<b>Well Name:</b> S BLANCO NAV 8	<b>Well Location:</b> T23N / R7W / SEC 8 / NWNE / 36.246887 / -107.593369	<b>County or Parish/State:</b> RIO ARRIBA / NM
<b>Well Number:</b> 2	<b>Type of Well:</b> OIL WELL	<b>Allottee or Tribe Name:</b> EASTERN NAVAJO
<b>Lease Number:</b> N00C14205607	<b>Unit or CA Name:</b>	<b>Unit or CA Number:</b>
<b>US Well Number:</b> 300392288000S1	<b>Operator:</b> DUGAN PRODUCTION CORPORATION

### Notice of Intent

**Type of Action:** Plug and Abandonment

## CONDITIONS OF APPROVAL

**Planned P & A Wellbore Schematic**

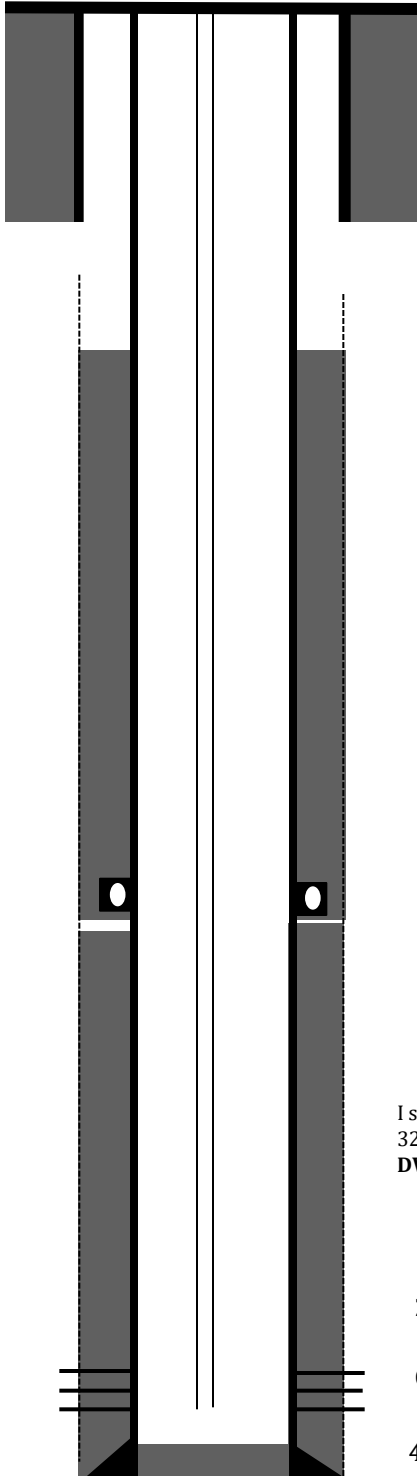
1. Plugging operations authorized are subject to the attached "General Requirements for Permanent Abandonment of Wells on Federal and Indian Lease."
2. The following modifications to your plugging program are to be made:
  - a. Plug 4 should be adjusted to cover 100' above BLM geologist pick for the Fruitland at 1670'. It is recommended to combine Plug 4 and Plug 5.
3. **Notification:** Farmington Office is to be notified at least 24 hours before the plugging operations commence at (505) 564 7750.

**Remarks:** Plug 4 should be adjusted to cover 100' above BLM geologist pick for the Fruitland at 1670'. It is recommended to combine Plug 4 and Plug 5.
